### ADDENDUM # 2

Proposal No.: **2024-13 CONL**

Roadway Improvements Project- Governor Winthrop Boulevard

#### ***Roadway Improvements Project- Governor Winthrop Boulevard***

DRAWING NO. 02  
JOB NO. 23.06  
CONTRACT NO. \_\_\_\_\_  
SHEET 2 OF 8 SHEETS

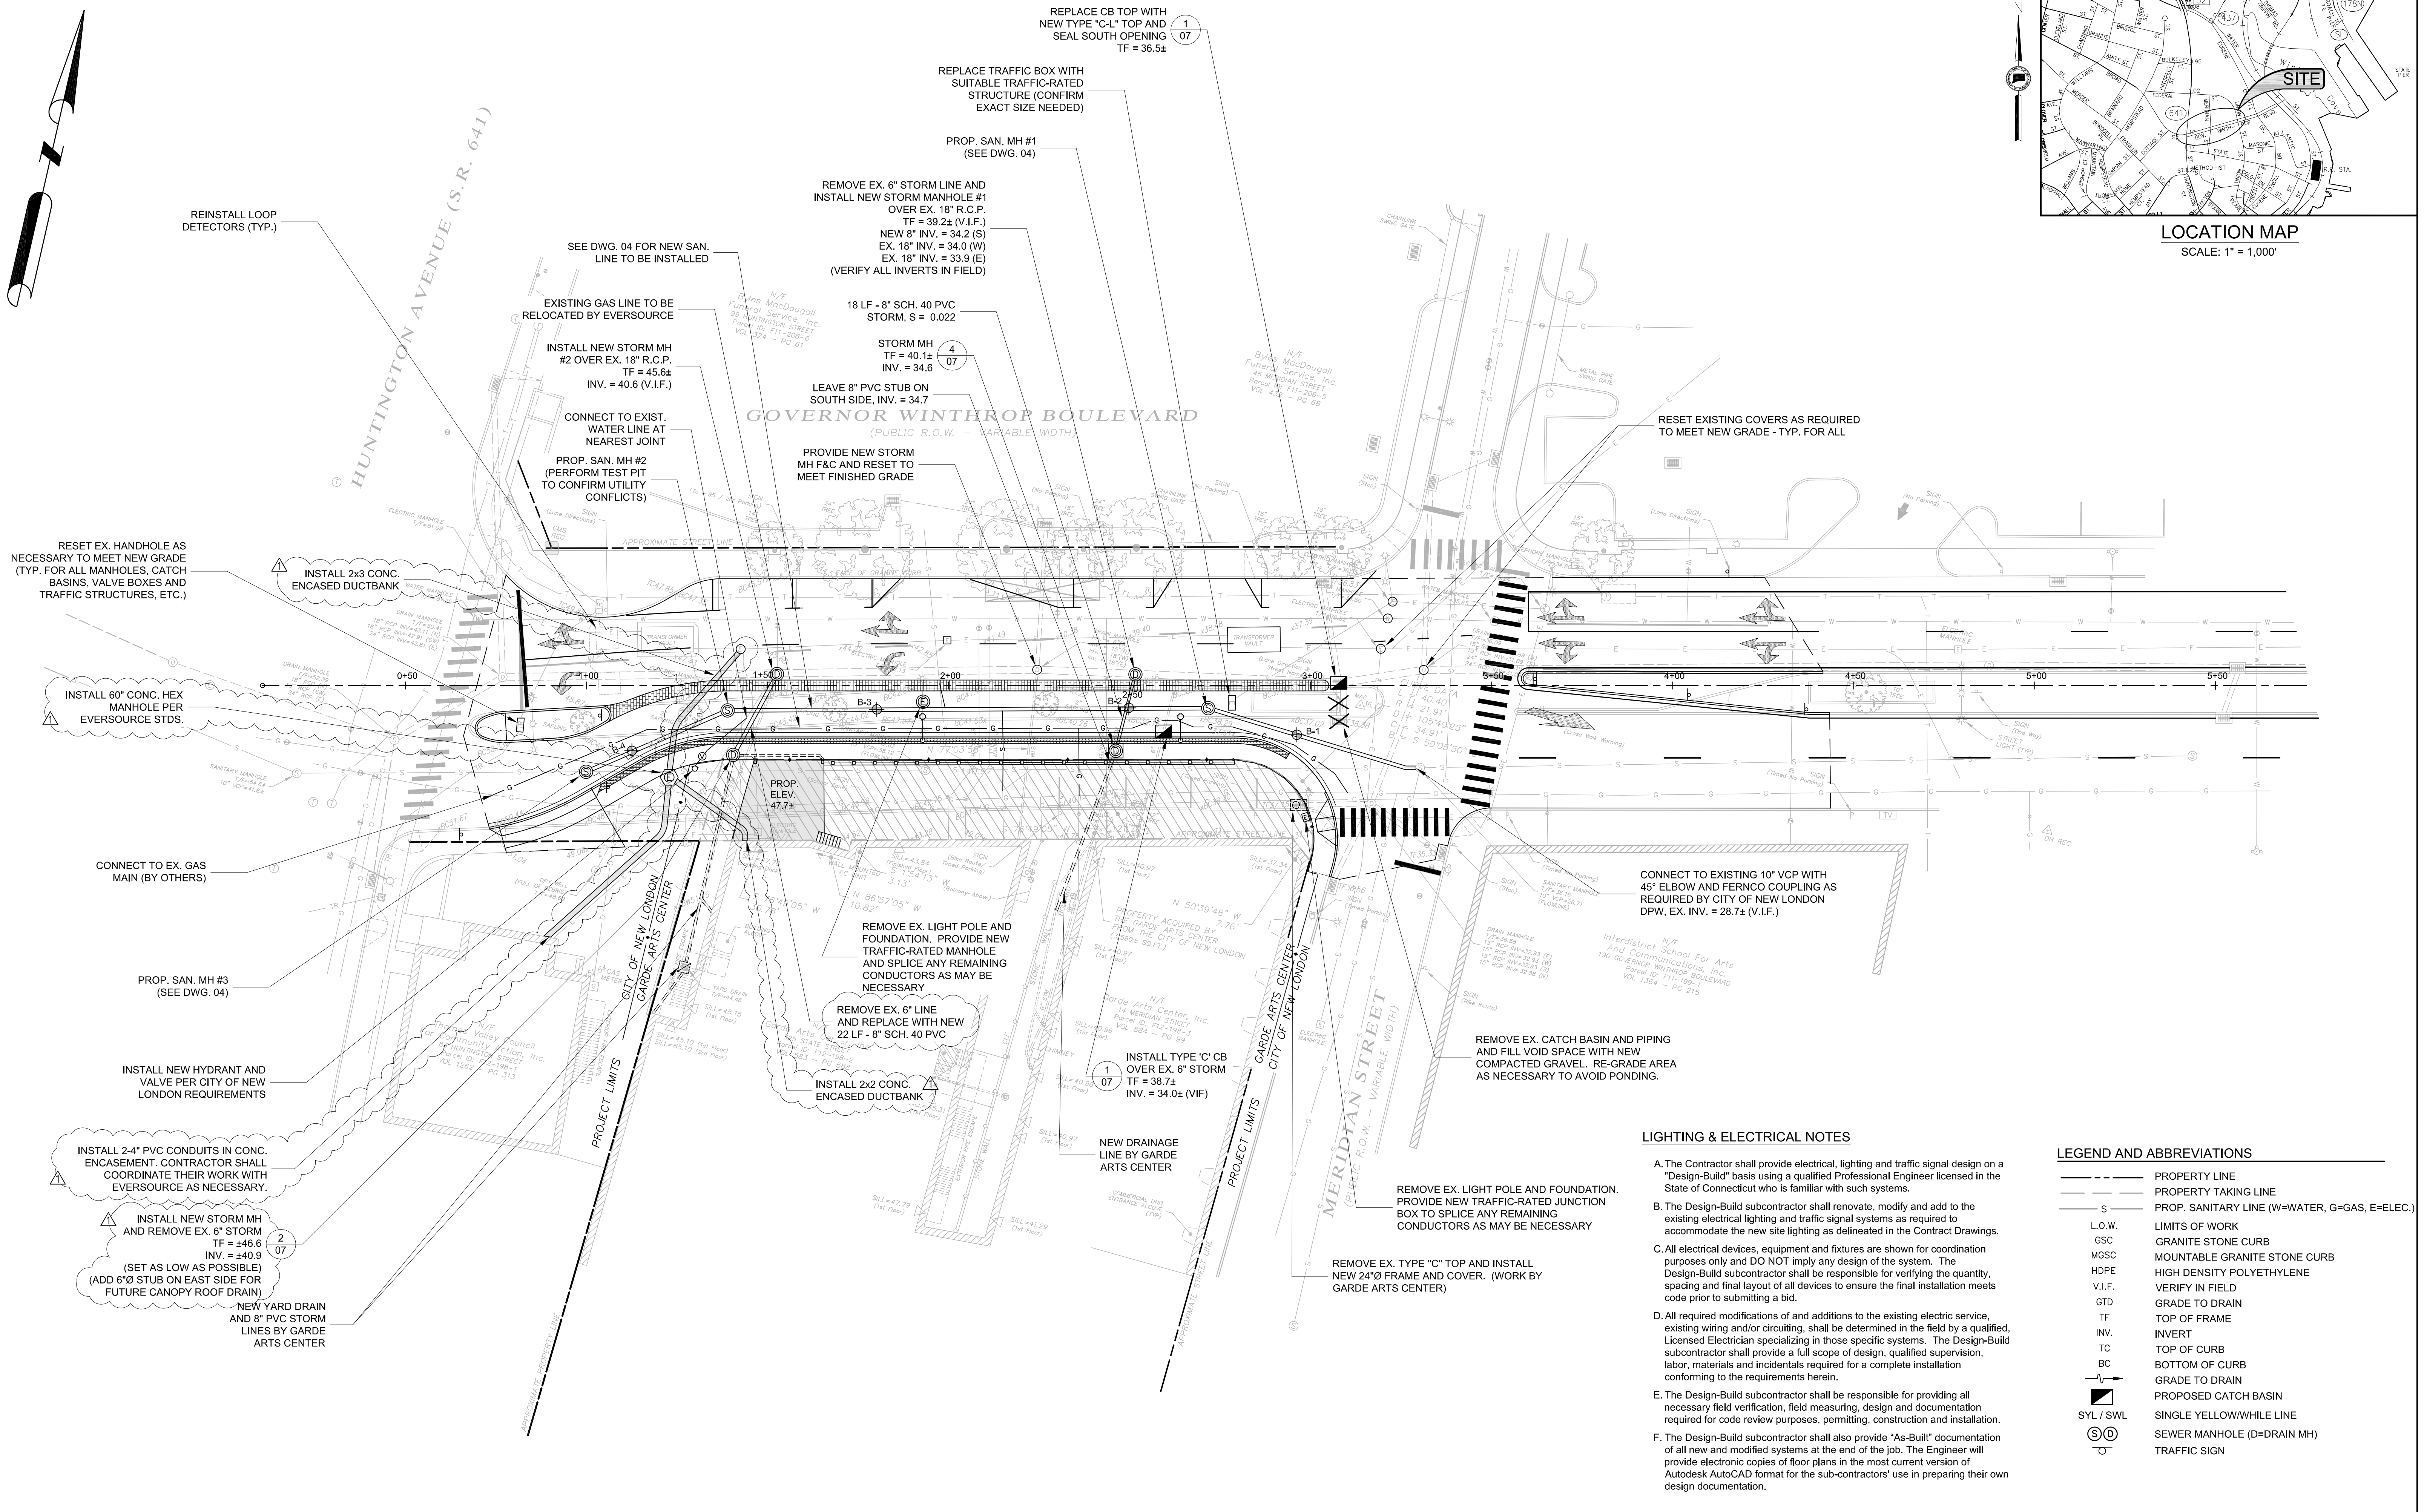
1. The Contractor shall install underground electrical ductwork to two buildings as per Eversource requirements as shown on revised site plan drawing 02 dated 2/27/2024. All material shall be as approved by Eversource. All conduit shall include pulling ropes for Eversource's use in installing the new conductors.

The new ductbanks shall penetrate the existing masonry foundations at a location to be determined by Eversource. Work shall include all excavation, trenching, bedding material, concrete forming and pouring, temporary roadway protection (temporary plates, traffic control), backfill and temporary asphalt patching. All work shall be inspected and approved by Eversource. The Contractor shall coordinate their work with Eversource at the time of switch-over to the new electrical services to each building.

2. The 8" PVC storm line to the west alley shall be reduced from 44 linear feet to 22 linear feet as shown on revised drawing 02. A 6" PVC stub shall be installed on the east side of the manhole for a future connection to the canopy roof drain. Invert depths shall be determined at the time of installation.

INSTALL 2-4" PVC CONDUITS IN CONC. ENCASUREMENT. CONTRACTOR SHALL COORDINATE THEIR WORK WITH EVERSOURCE AS NECESSARY.

INSTALL NEW STORM MH AND REMOVE EX. 6" STORM  
TF = ±46.6  
INV. = ±40.9  
(SET AS LOW AS POSSIBLE)  
(ADD 6" Ø STUB ON EAST SIDE FOR FUTURE CANOPY ROOF DRAIN)

INSTALL 2x3 CONC. ENCASED DUCTBANK

REMOVE EX. 6" LINE AND REPLACE WITH NEW 22 LF - 8" SCH. 40 PVC

INSTALL 2x2 CONC. ENCASED DUCTBANK

NO.	DESCRIPTION	DATE
ADDENDUM #2 - ADD ELECTRIC MANHOLE ETC.		2/27/2024
REVISIONS
